Our Case Number: ABP-317767-23

**Re: Proposed construction of 39 residential units, widening of Pausdeen Bridge and all associated site works.
Newtown/Ardclough Road, Newtown, Celbridge, Co. Kildare.**

Planning Observation Submissions to An Bord Pleanála

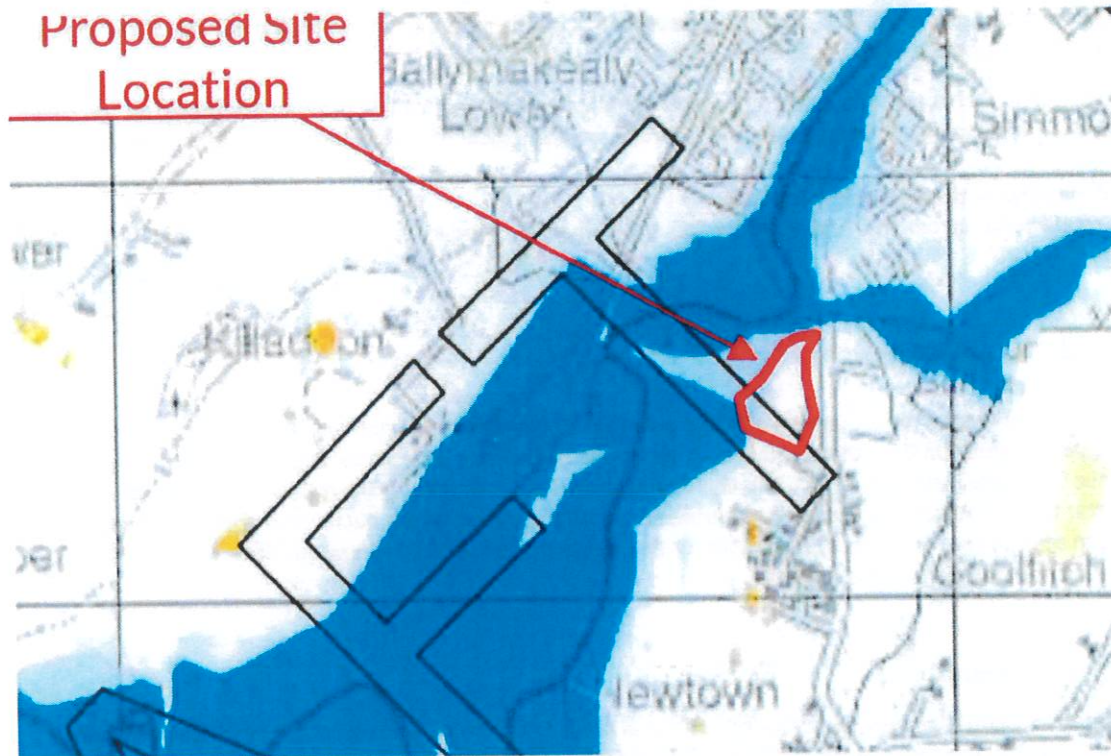
PFRA: Tobin report highlights the OPW Preliminary Flood Assessment (PFRA) and clearly state themselves that there is flooding in the southwest corner of the site.
